MIL-PRF-19500/455C
AMENDMENT 2
14 July 2000
SUPERSEDING
AMENDMENT 1
18 August 1999

PERFORMANCE SPECIFICATION SHEET

SEMICONDUCTOR DEVICE, TRANSISTOR, NPN, SILICON, POWER SWITCHING
TYPES 2N5664, 2N5665, 2N5666, 2N5666S, 2N5667, AND 2N5667S
JAN, JANTX, JANTXV, AND JANS

FIGURE 3. JANHC and JANKC A-version die dimensions.

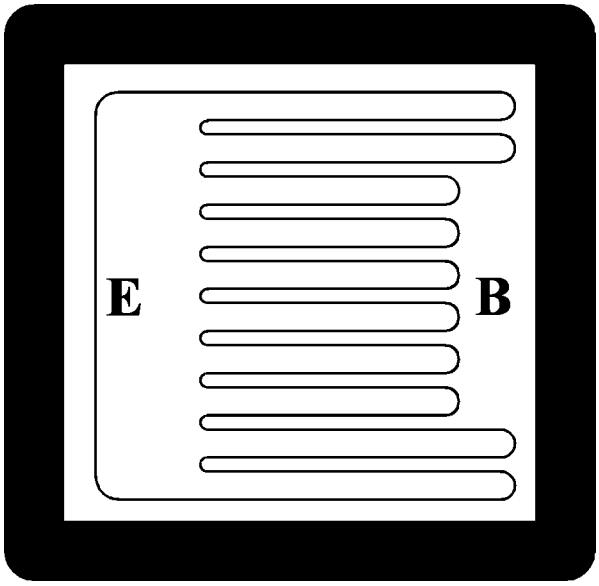
* 3.4 second line; delete "figures 1 and 2 herein." and substitute "figures 1, 2, and 3 herein."

3.4 Interface requirements and physical dimensions. The interface requirements and physical dimensions shall be as specified in MIL-PRF-19500 and on figures 1, 2 and 3 herein.
